Access Compliance Report

Public Rights-of-Way

(Curb Ramps)

Intersection ID: 48953	Main Street: DAVID_JENNINGS_AV	Cross Street: GATESMILLS_AV	Location: W
ADA ID: 66F8EB4179B5	Ramp Type: Perp	Initial Pass/Fail: Fail	Overall Compliance: No
Severity Score: 12.5			
Codes/Mitigation Info/Possible Solution		Field Measurements/Component Compliance

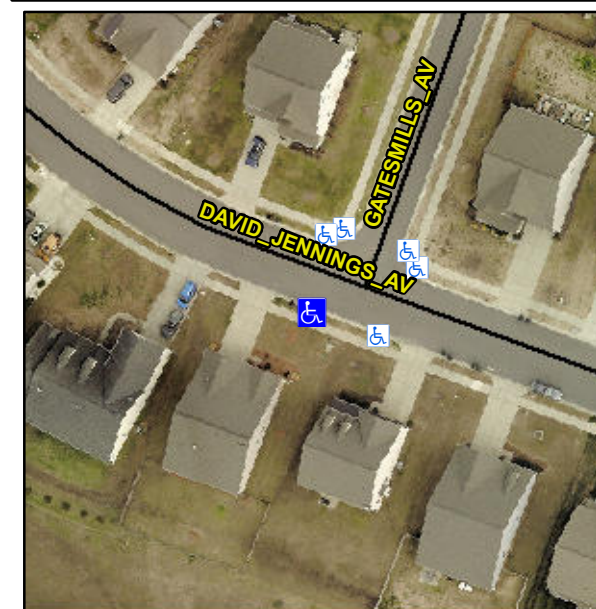
Not Found, R304.2.2

Compliance	Description	Data	Compliance	Description	Data
N/A	Ramp Length (in)	46.5	No	Ramp Slope (%)	10.1
Yes	Ramp Width (in)	48.0	Yes	Ramp XSlope (%)	1.5
N/A	Flare Type LT	N/A	N/A	Flare Type RT	N/A
N/A	Flare Slope LT (%)	N/A	N/A	Flare Slope RT (%)	N/A
N/A	Flare Traversable LT?	N/A	N/A	Flare Traversable RT?	N/A
N/A	Landing Length (in)	N/A	N/A	DWS Provided?	N/A
N/A	Landing Width (in)	N/A	N/A	DWS Contrast?	N/A
N/A	Landing Slope (%)	N/A	N/A	DWS Length (in)	N/A
N/A	Landing X Slope (%)	N/A	N/A	DWS Full Width?	N/A
N/A	Landing Curb? (Y/N)	N/A	N/A	DWS Offset (in)	N/A
N/A	Shared Landing?	N/A			
N/A	Gutter Ponding?	N/A	N/A	Gutter Slope (%)	N/A
N/A	Gutter Lip Ht (in)	N/A	N/A	Gutter X Slope (%)	N/A
N/A	Painted X Walk1?	No	N/A	Painted X Walk2?	N/A
	X Walk 1 Direction	To N		X Walk 2 Direction	N/A
N/A	X Walk 1 Width (in)	N/A	N/A	X Walk 2 Width (in)	N/A
	X Walk 1 Slope (%)	1.3		X Walk 2 Slope (%)	N/A
	X Walk 1 X Slope (%)	1.2		X Walk 2 X Slope (%)	N/A

Remove & Replace Entire Ramp.
